TECHNICAL SERVICE BULLETIN

Subject: TSB-ECN151063 – New diode Added on Scrub Relays

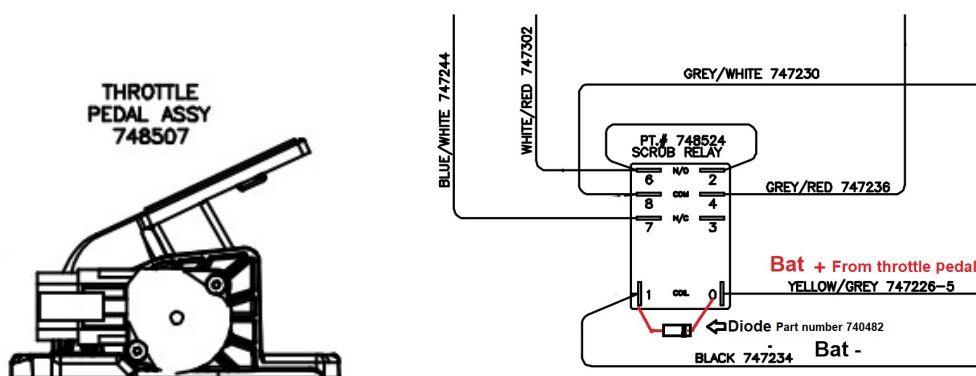
Reason for Change

The scrub control relay may, in some cases cause damage to the switch inside the throttle pedal.

Improvement

The diode added to the relay. The diode acts as surge protector for the switch, located inside the throttle pedal.

Reference Instructions – Order diode part number 740482 along with the throttle pedal 748507, when replacing, if the brush switch inside the throttle has failed.
